**STORM ANALYSIS ADDENDUM TO SDAP 18-02605**

**SEASIDE AT KINGSTON**  
**S.D.A.P.**

**JOB NO. 9946-17**

**DECEMBER 2020**

FIG 1

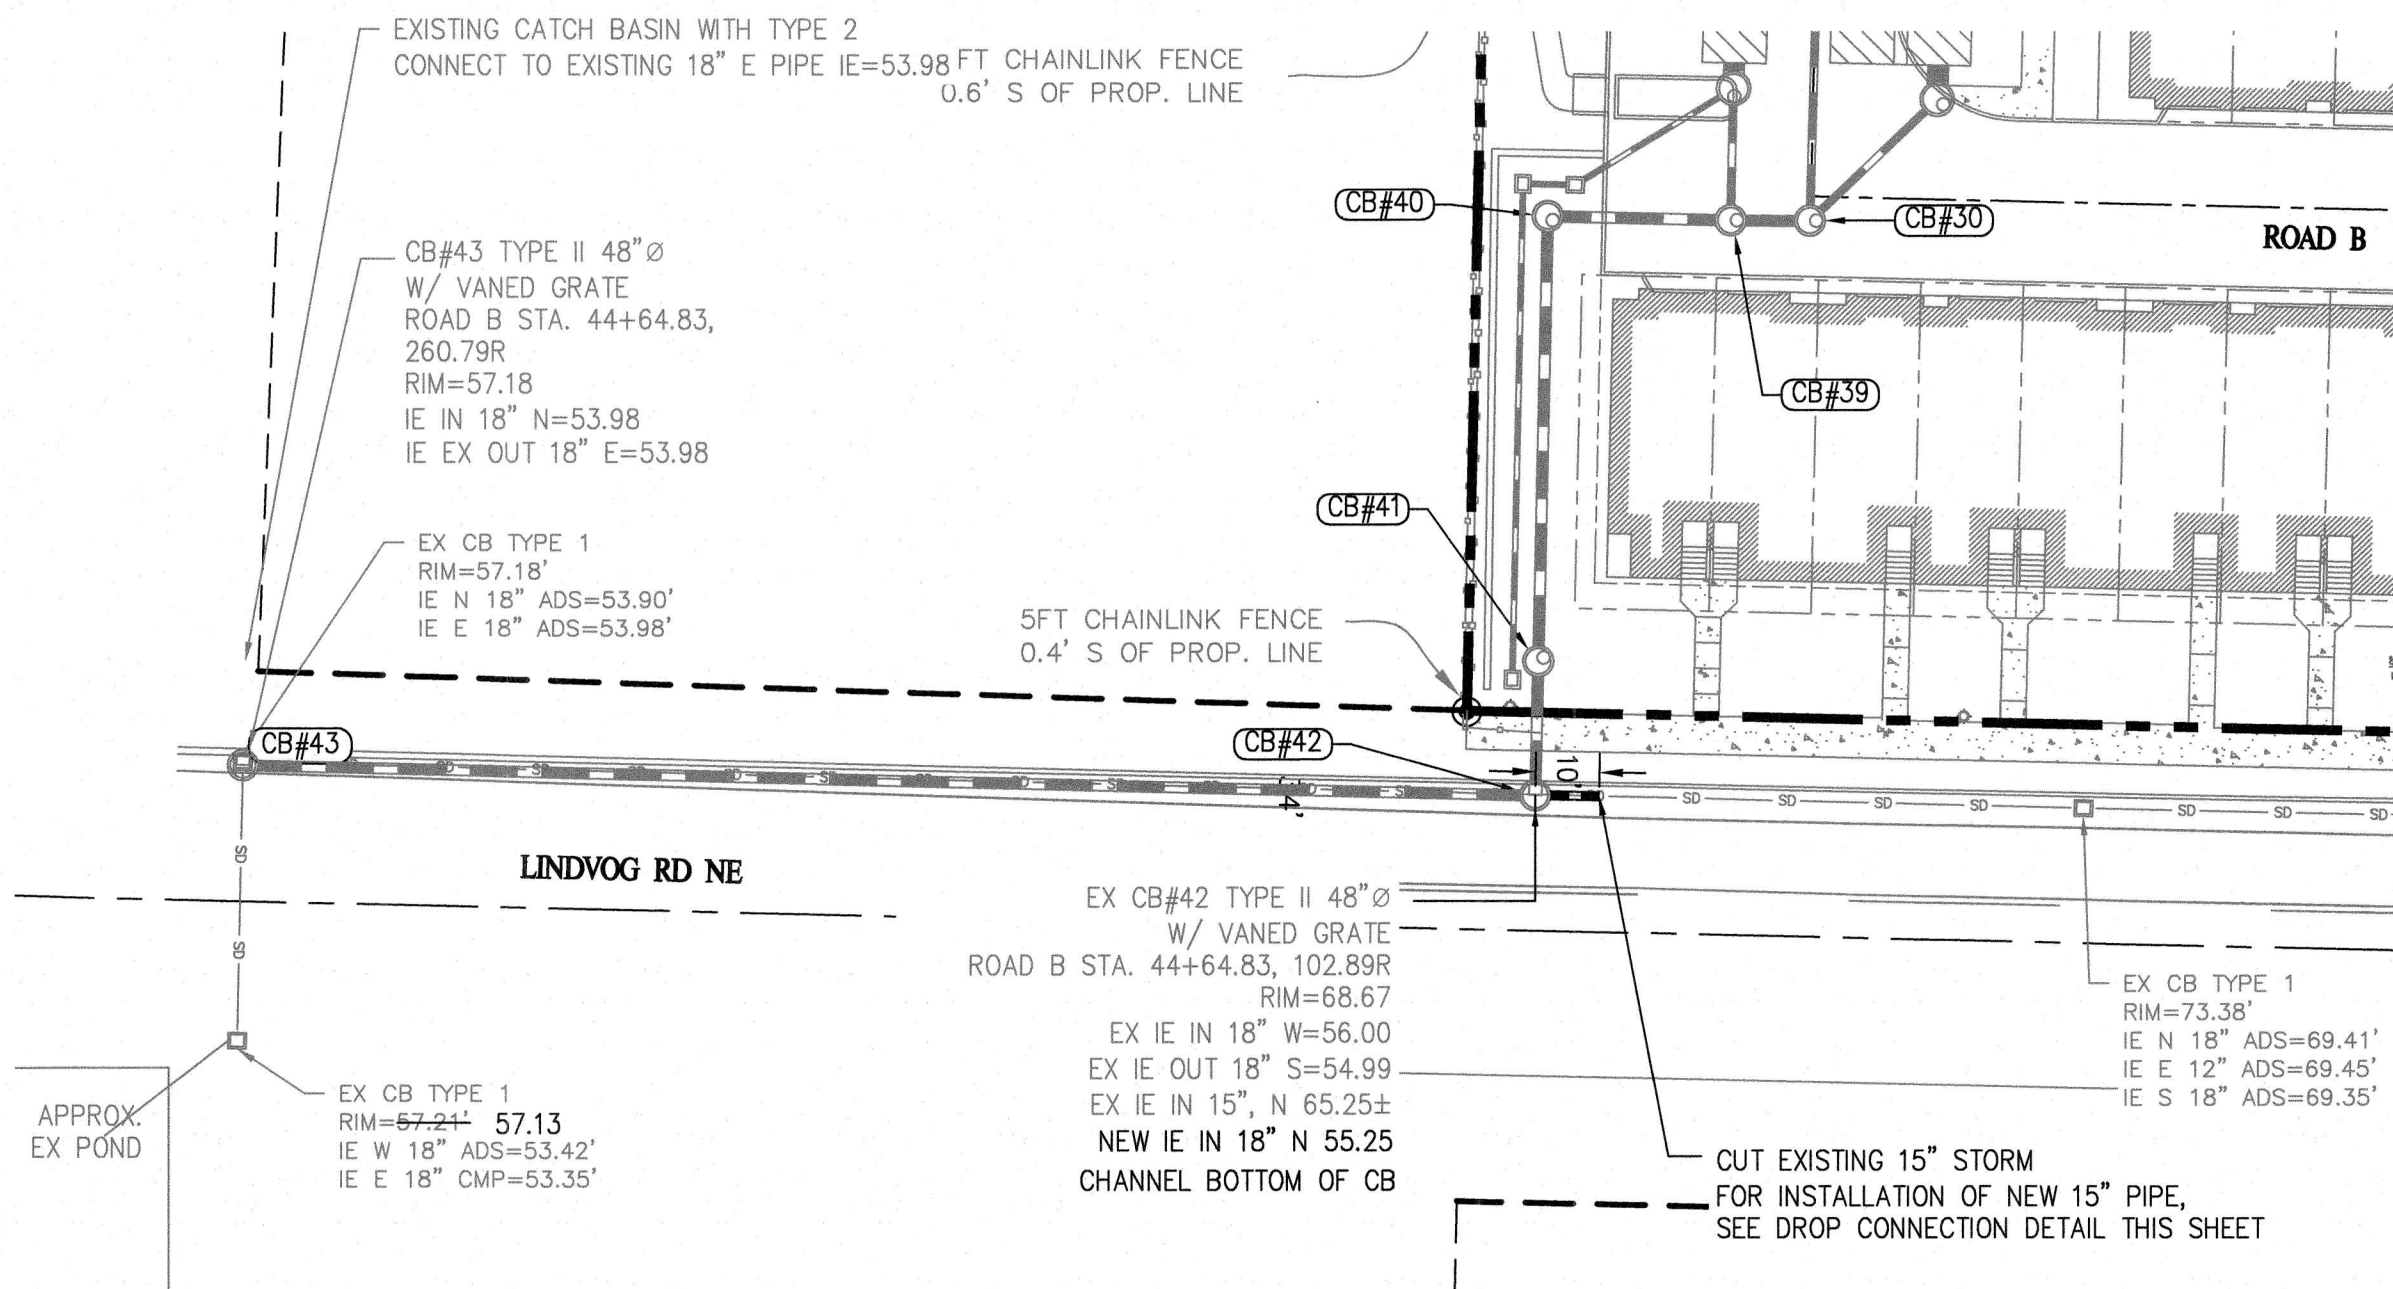
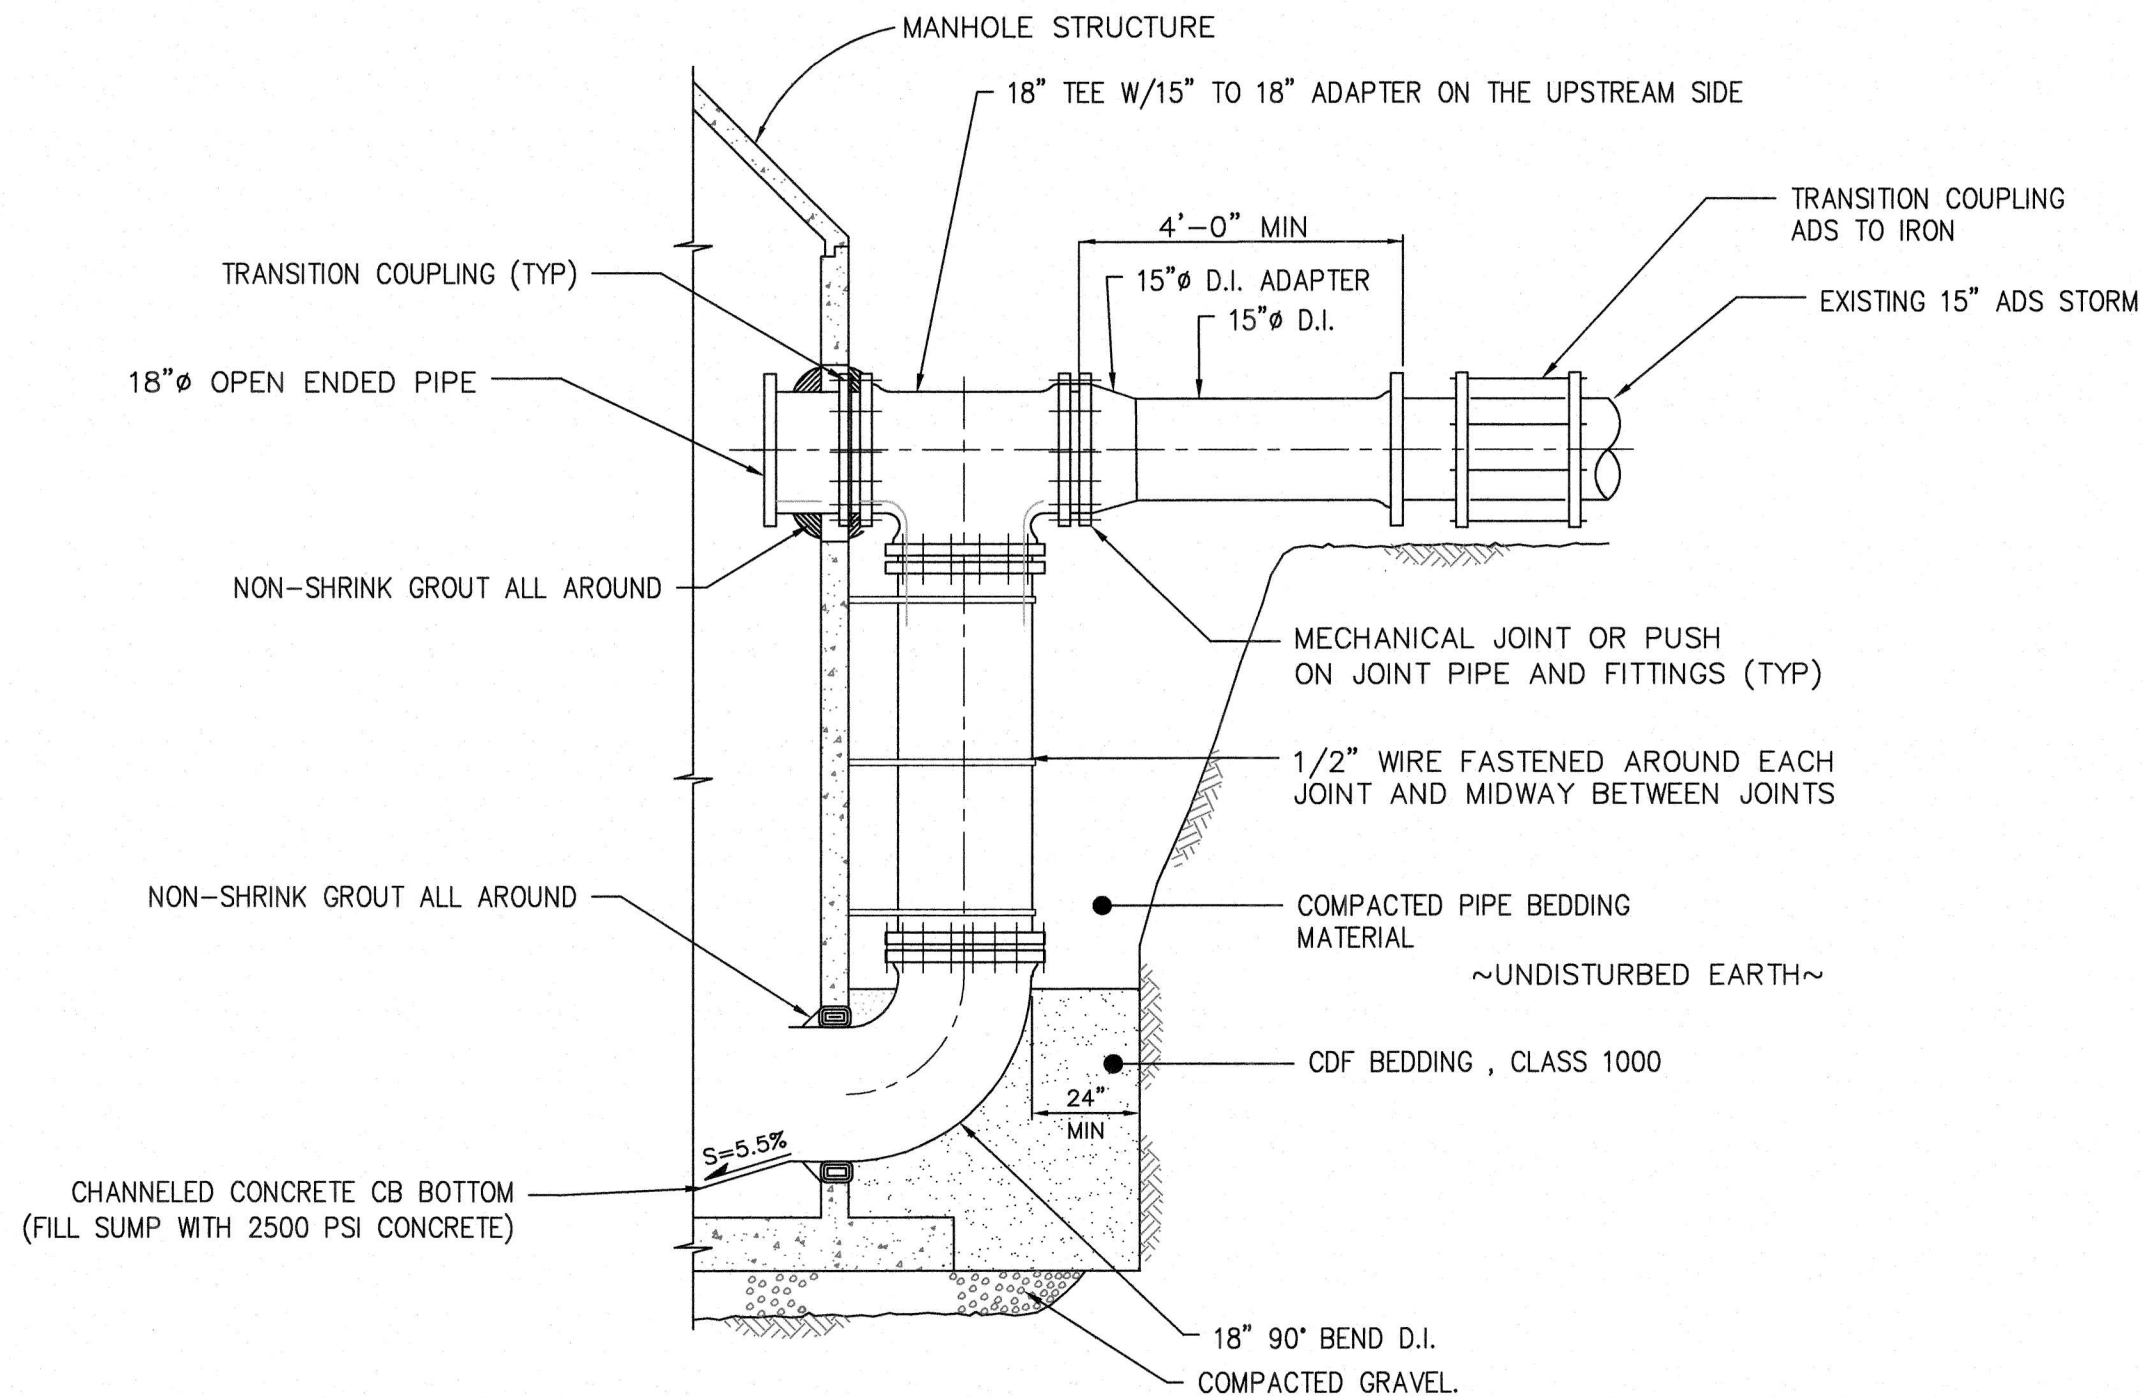
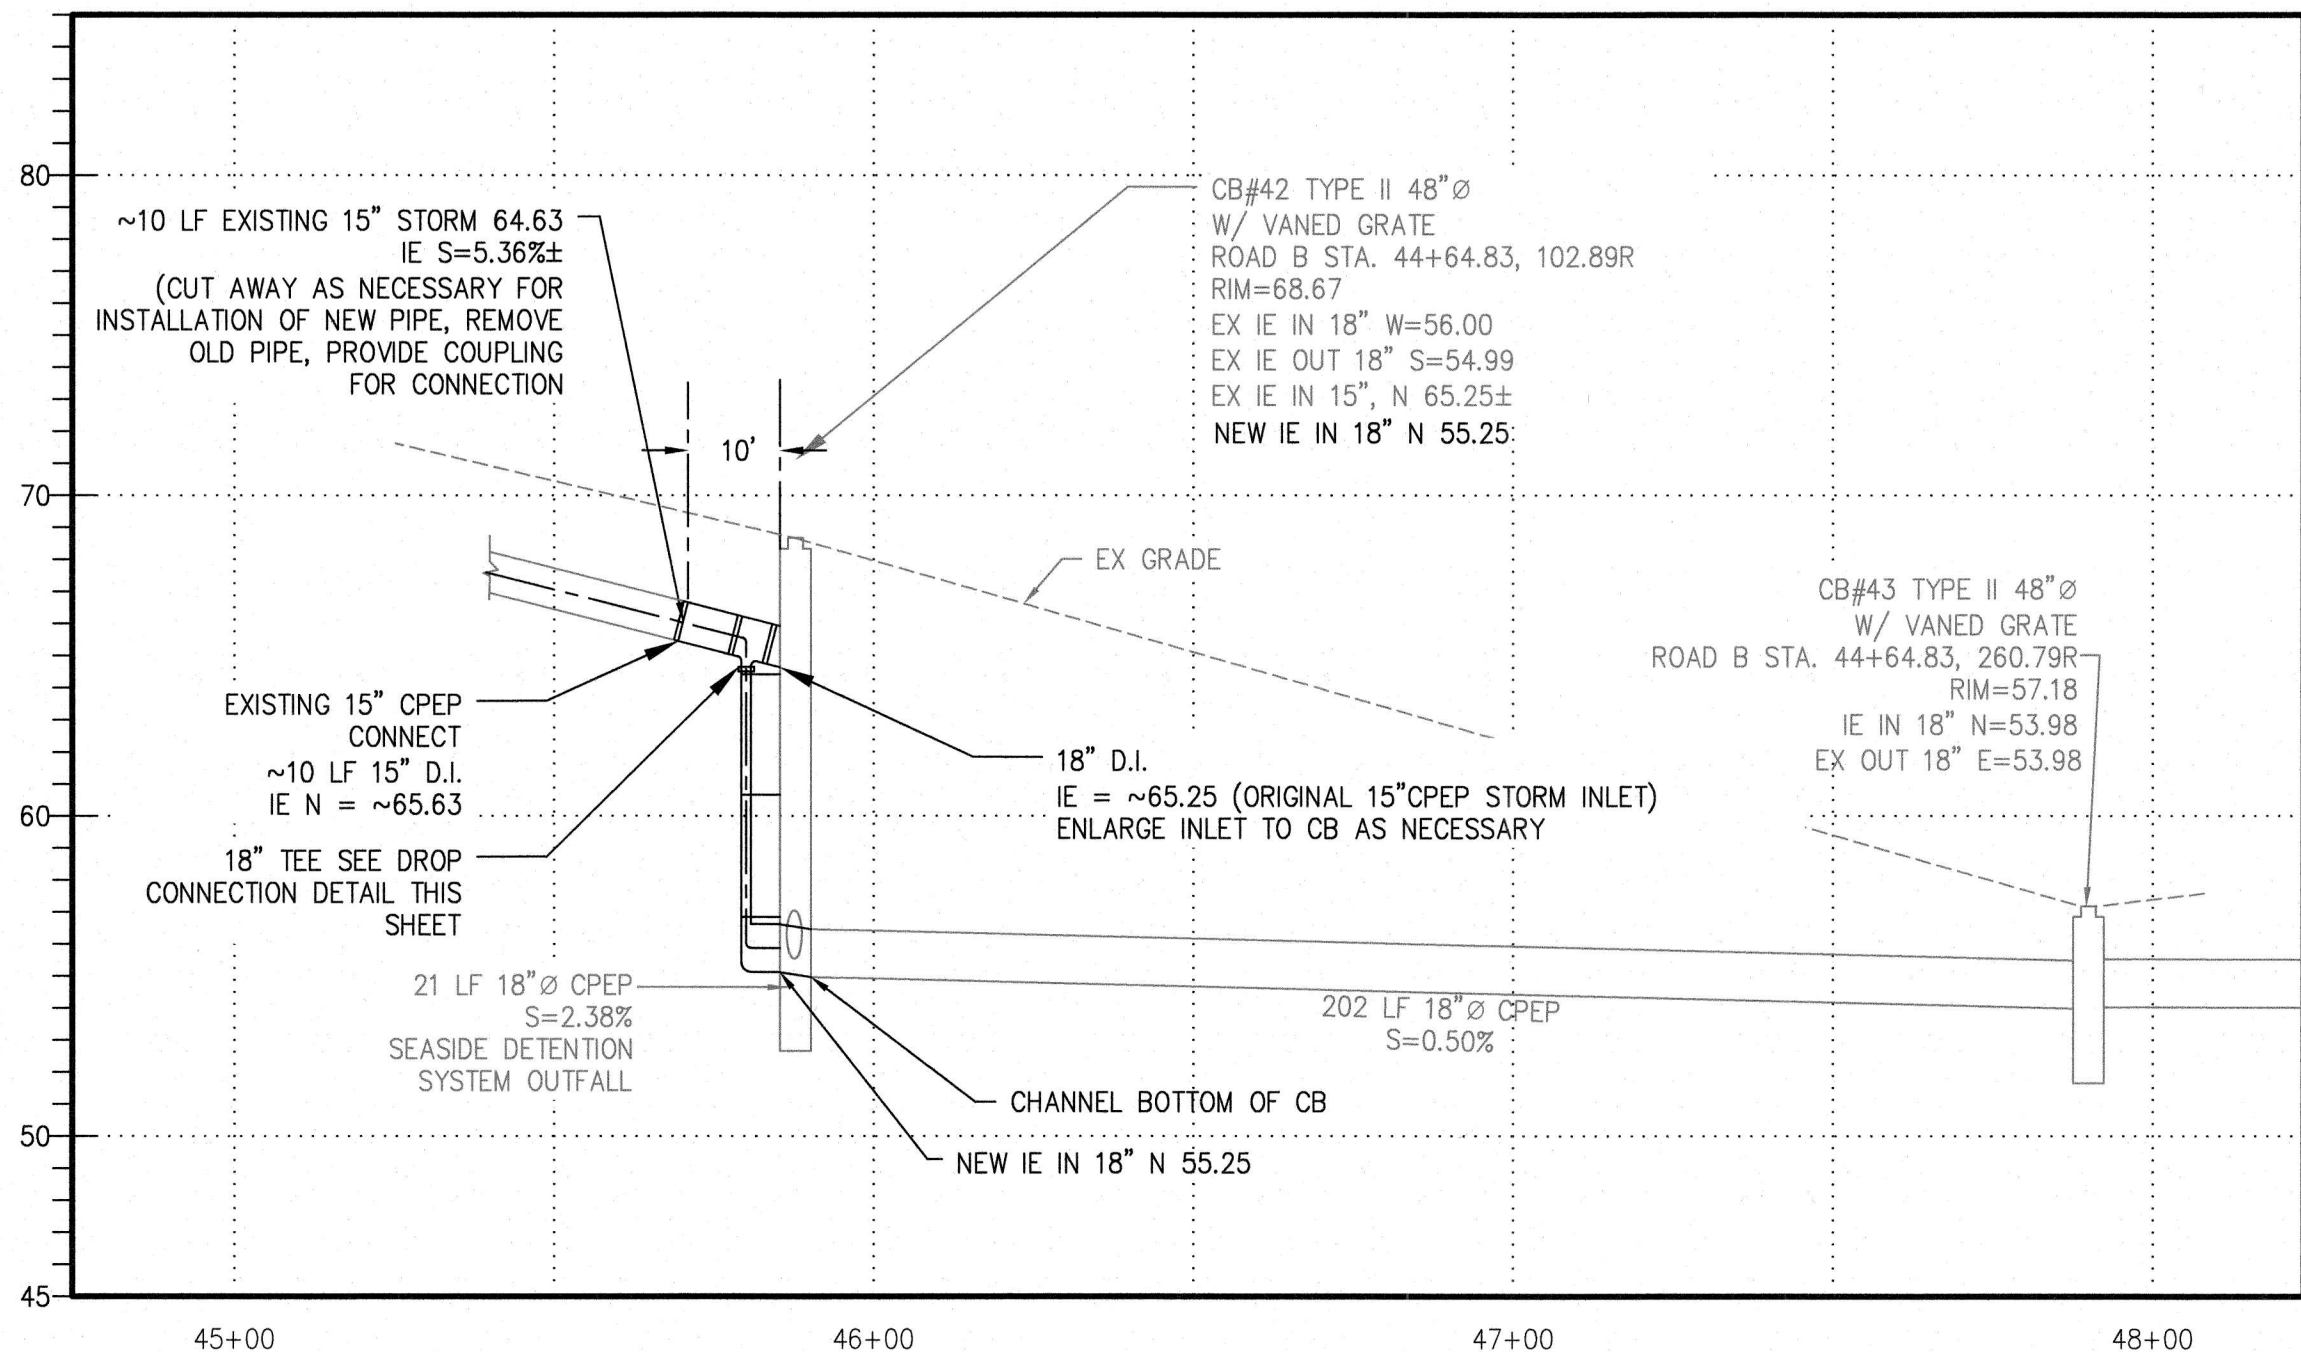
This addendum analyzes a revision to the approved plans that includes removal of the 10' drop into CB #42 and instead conveying runoff directly to the bottom of the CB, which also improves the conveyance capacity by preserving the velocity of the stormwater. No changes are proposed to the storm mitigation or conveyance within Seaside for this addendum.

The proposed stormwater improvements on site are unchanged from the approved report. The only revision proposed with this addendum is the entrance to CB #42, which is currently proposed to be an outside drop connection, as well as channeling the bottom of CB #42. This addendum analyzes the impact of these improvements, as well as backwater into the storm system for the site itself.

REVISIONS					NO.	DATE	BY	DESCRIPTION	DESIGNED	BY	DATE
1	12/20	RHL	REVISED DOWNSTREAM CONVEYANCE AT CB#42 WITH CONVEYANCE OUTSIDE DROP	DRAWN	RHL	12/20					
				CHECKED	NLOI	12/20					
				APPROVED							
				ACCEPTED
